Engineering Land Use Application Comments

To: Joy Chang, Senior Planner, Planning Department
From: Bob Galati, P.E., City Engineer, Engineering Department
Craig Christensen, P.E., Civil Engineer, Engineering Department
Project: T-S Corporate Park (LU 2020-01)
Date: May 14, 2020

~ 33 SEE SHEET
C3.0 FOR
LOCATIONS OF
HYDRANTS

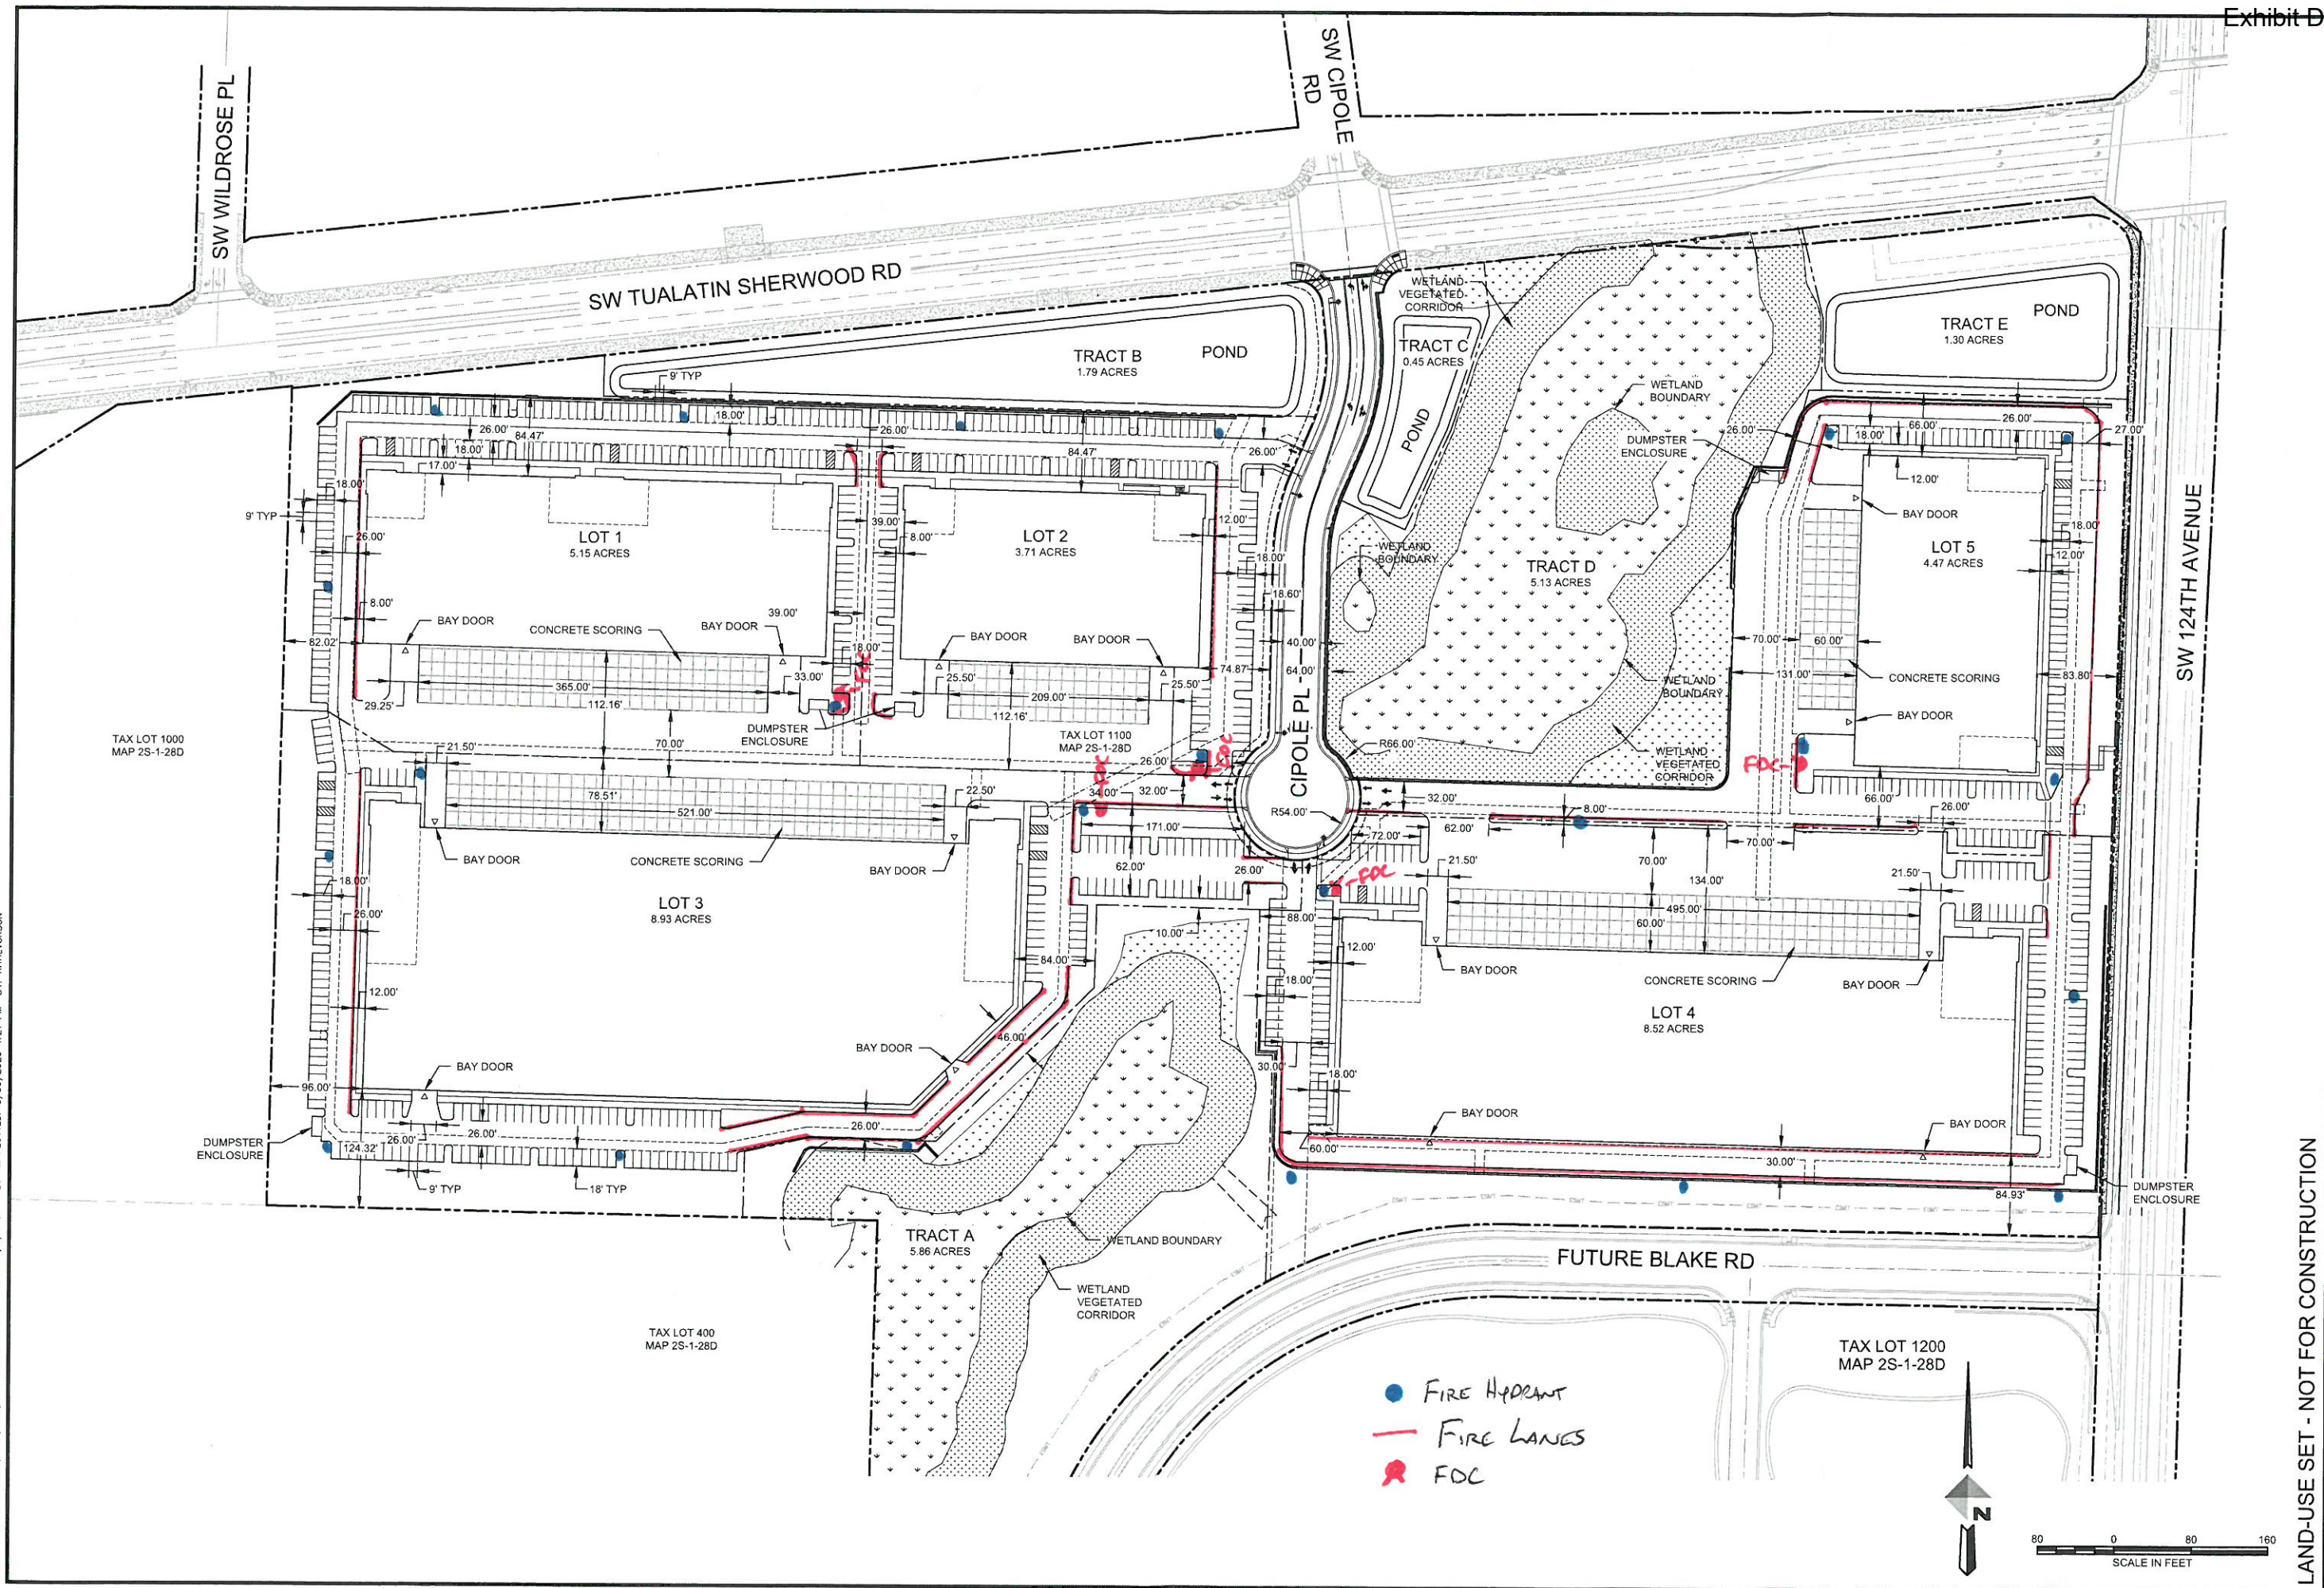
SPRINKLER REDUCTION: $8,000 \text{ GPM} (0.75) = 2,000 \text{ GPM}$ TOTAL FIRE FLOW: 2,000 GPM + FIRE SPRINKLER DEMANDBLDG D: $145,624 \text{ ft}^2 = 8,000 \text{ GPM}$ (OFC TABLE B105.2) $8,000 \text{ GPM} = 8$ OR MORE HYDRANTS (OFC TABLE C105.1)

8 HYDRANTS w/ AVERAGE SPACING OF 200 FT

SPRINKLER REDUCTION = $8,000 \text{ GPM} (0.75) = 2,000 \text{ GPM}$ TOTAL FIRE FLOW: 2,000 GPM + FIRE SPRINKLER DEMANDBLDG E: $62,212 \text{ ft}^2 = 5,250 \text{ GPM}$ (OFC TABLE B105.2) $5,250 \text{ GPM} = 6$ HYDRANTS (OFC TABLE C105.1)

6 HYDRANTS w/ AVERAGE SPACING OF 250 FT
